**Re:** 23 Howe Rd Special Permit # 129-16

# Consistency Ruling (#129-16) - 23 Howe Road

Severini Residence

# Approved Plans per #129-16

Alt Second Floor  
& Attic Floor Plans

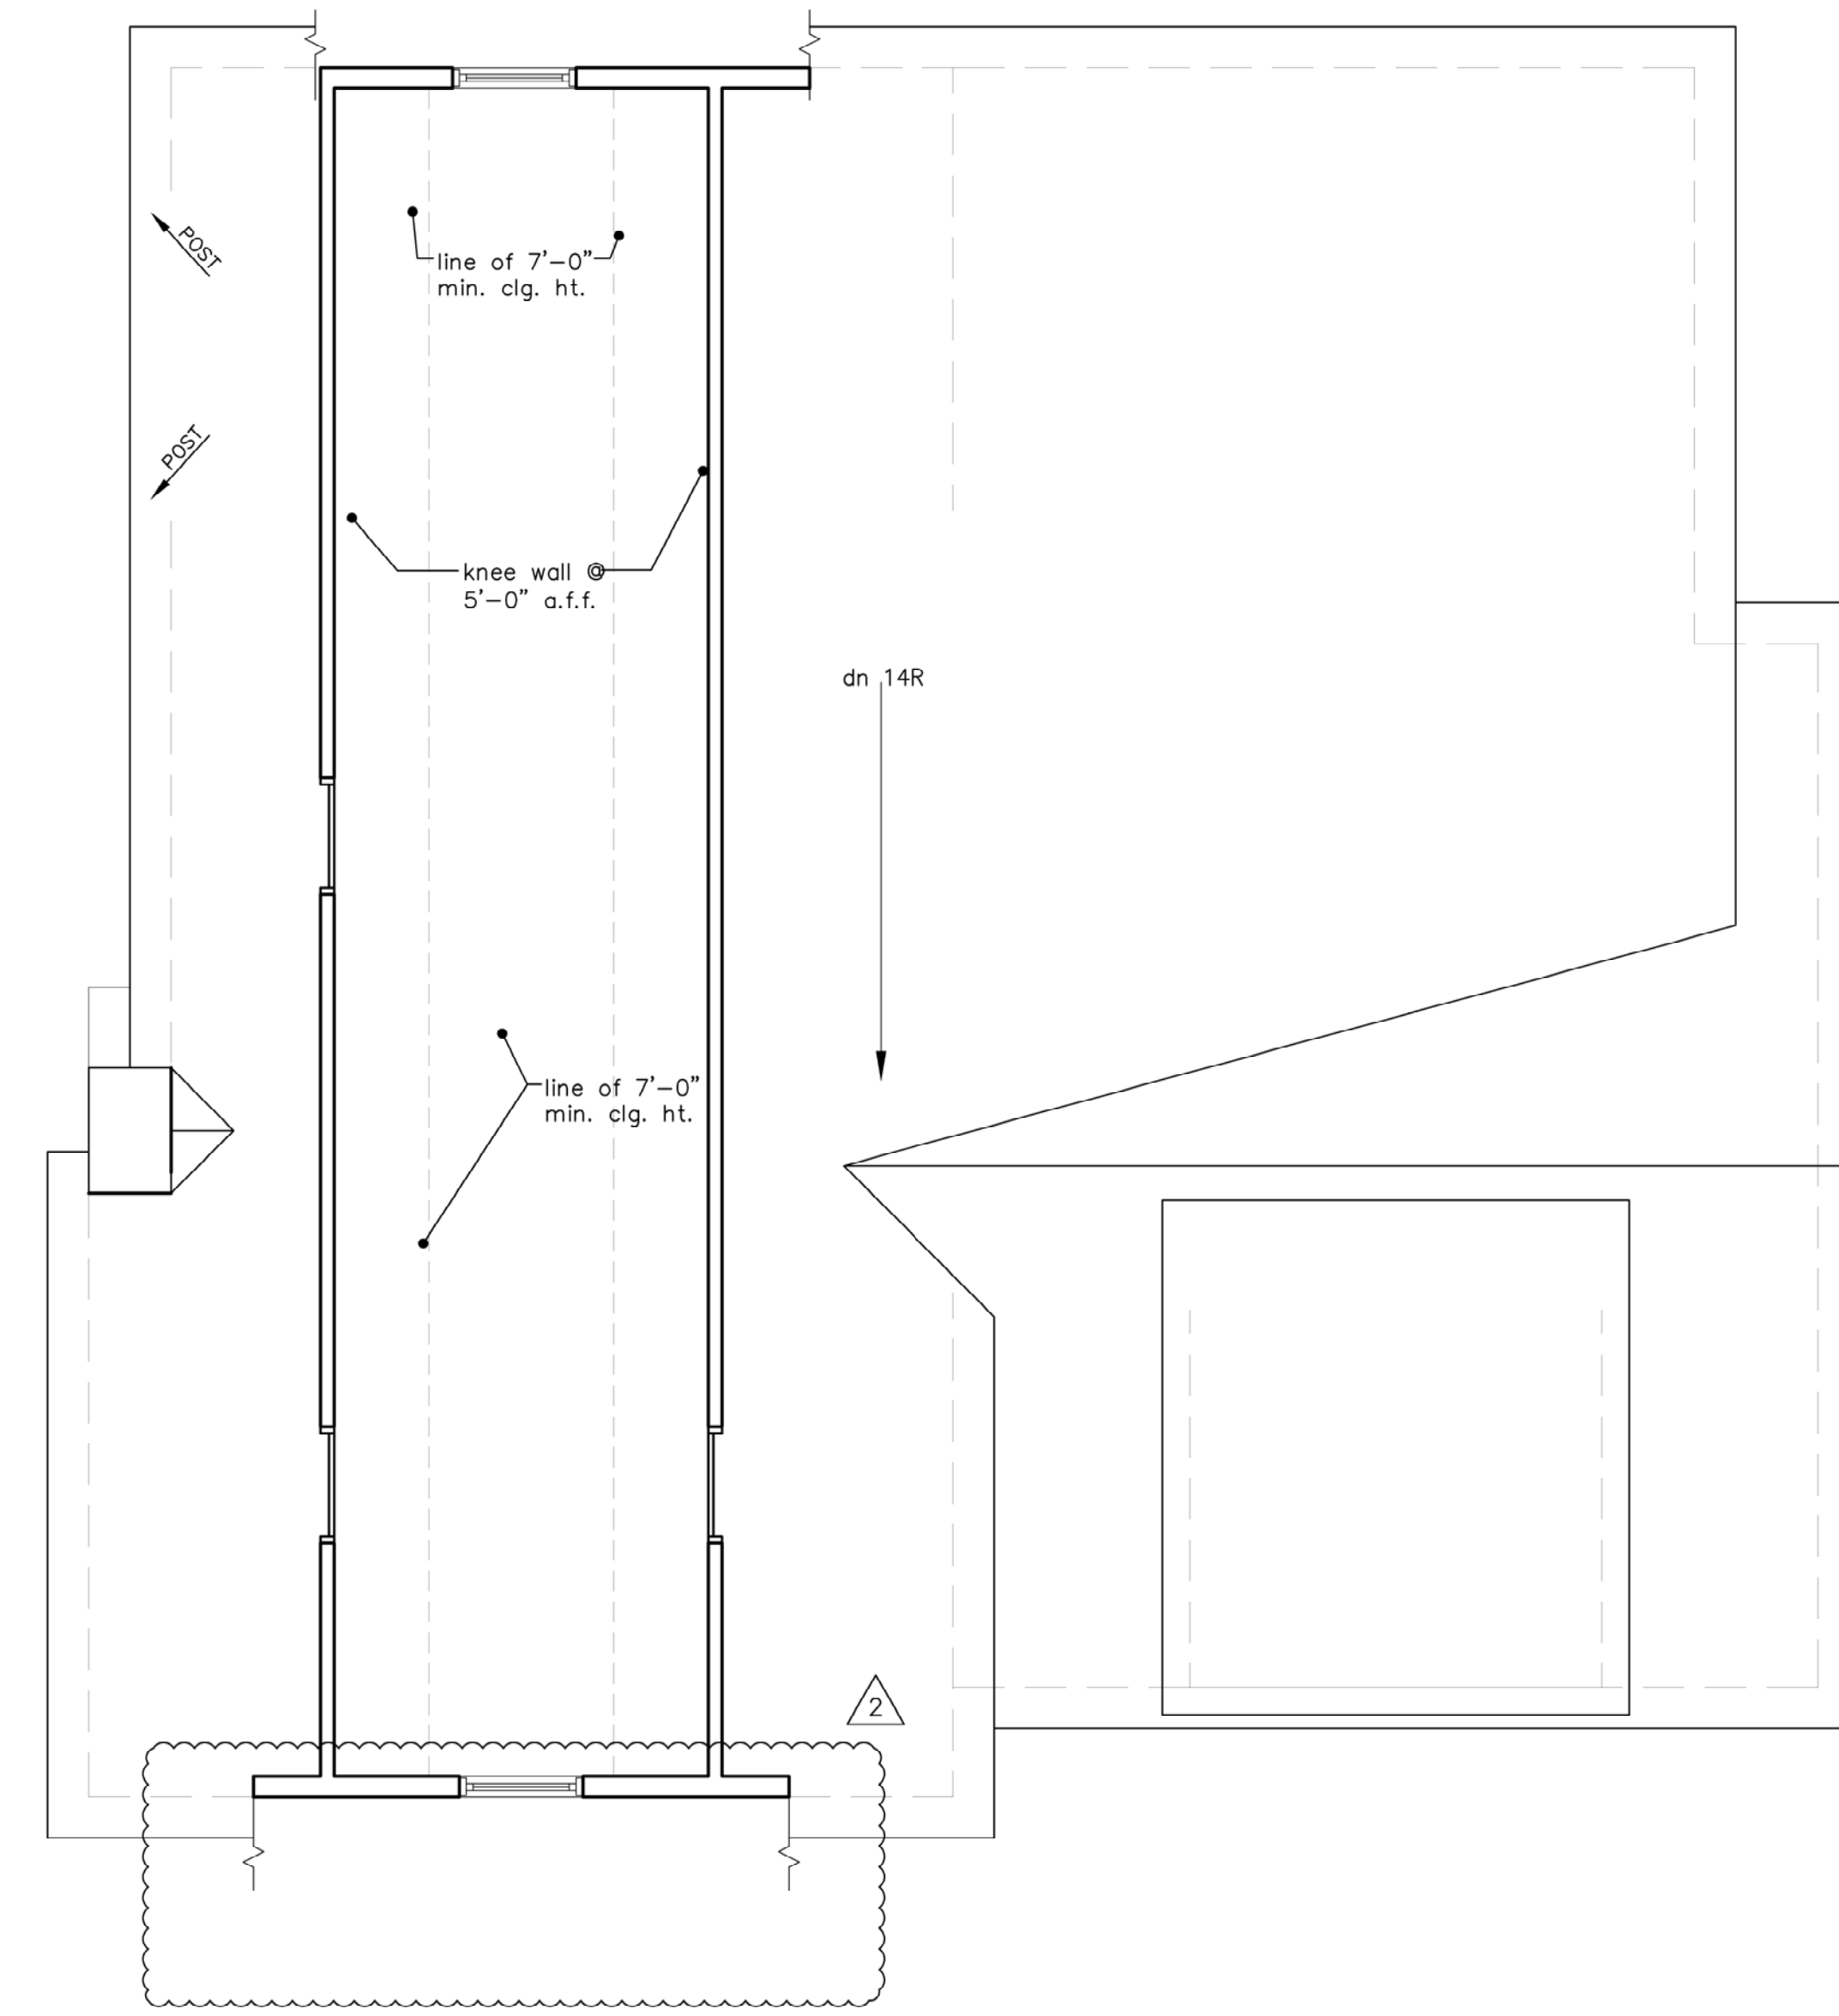
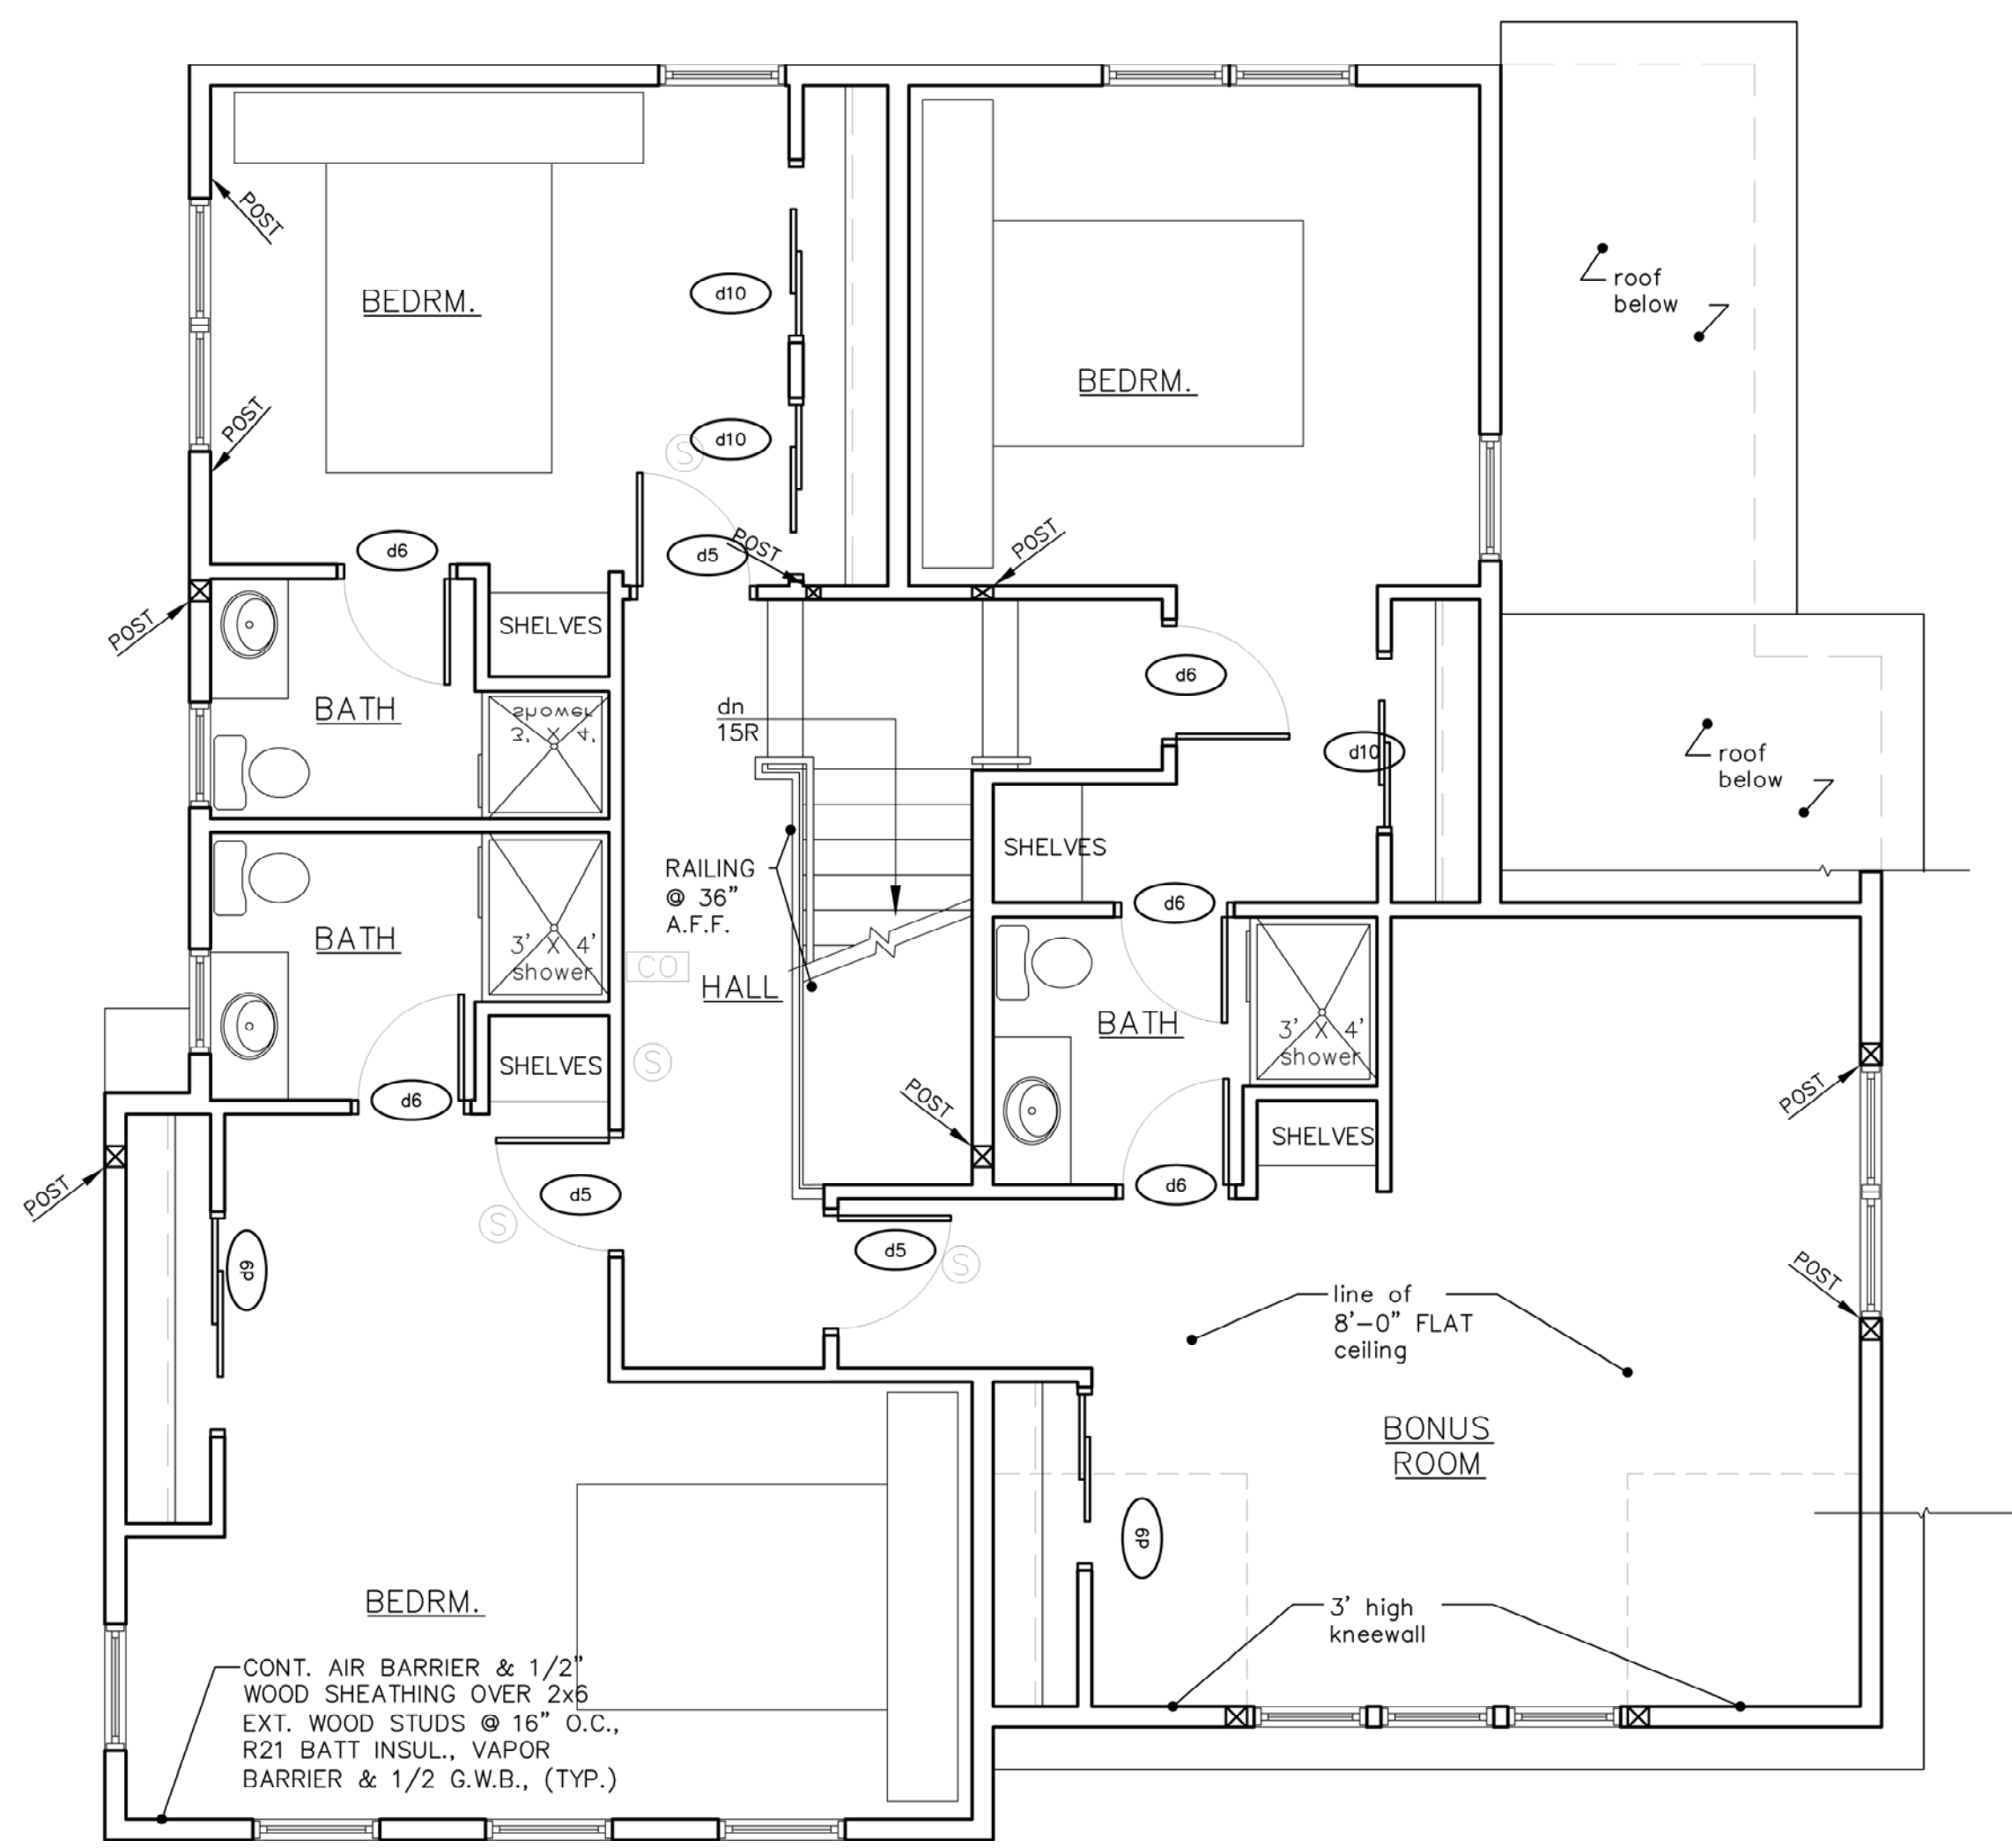
My client was originally Richard Severini and upon his passing, his longtime companion Sue Santos inherited the land with the approved plans. As she was starting to move forward to build the home for herself, she asked me to make some changes, specifically eliminating the 3<sup>rd</sup> floor space in favor of larger second floor.

These revisions actually simplify the rooflines, remove all the dormers and any living space on the third floor. We used some of that square footage to add a small sunroom in place of a larger patio to the first and raise the roof over the kitchen, eliminating the kitchen volume ceiling in favor of adding living space in that area. The lot setbacks and height of the main ridge are unchanged. We reviewed the FAR chart and method for square footage with Anthony Ciccariello to make sure we were counting the areas properly.
